Addendum/Supplement.

3rd July 2019.

Chapter 6, OzInverter for the USA, 60HZ 120vac.

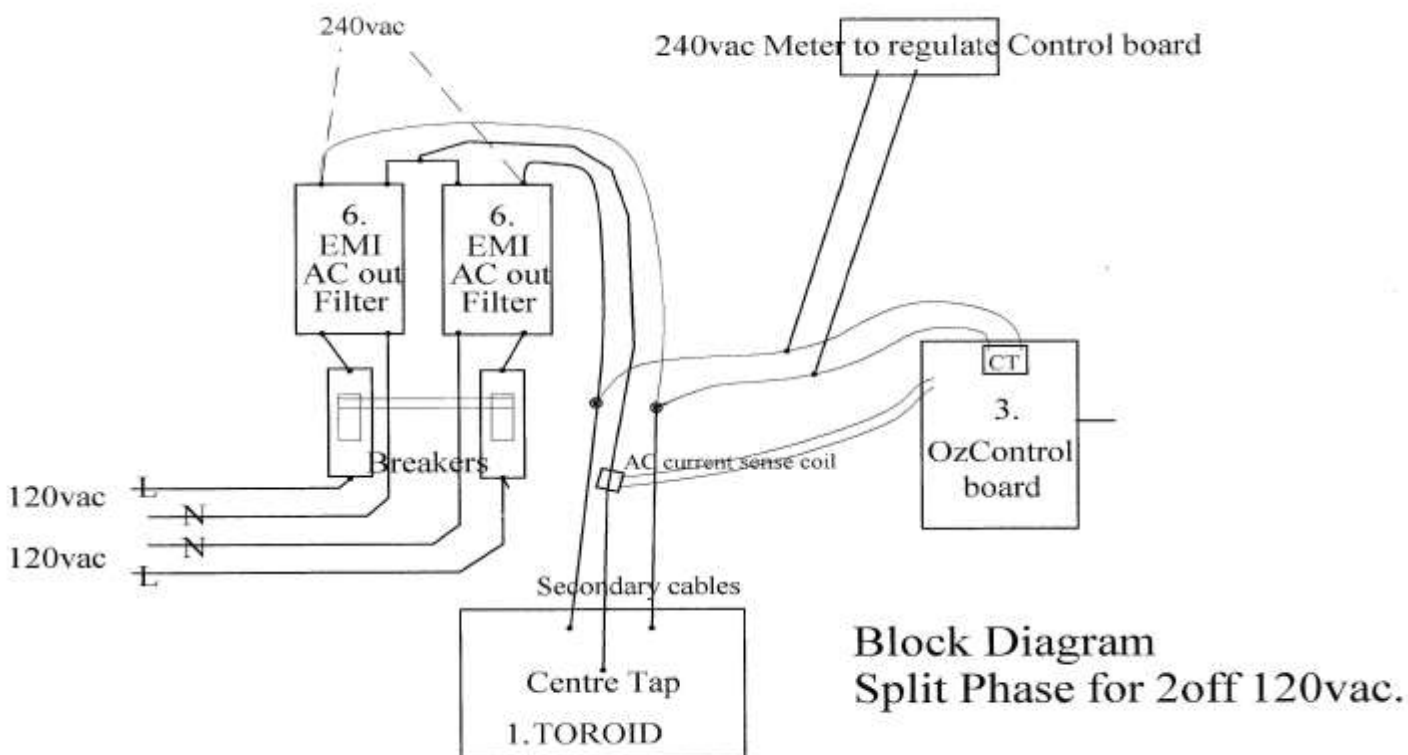
The split phase will require 8 off EMI FILTERS as shown in the book, and these will require wiring up as above Split Phase Block Diagram.

PLEASE fit breakers as shown above and photo right on the LIVE cables.
PLEASE seek assistance from a competent electrician regards the breakers
and your local safety codes. As the photo right, I prefer to have the breakers
physically tied so if the breaker activates on one of the 120vac split phases it
also shuts down the other split phase.
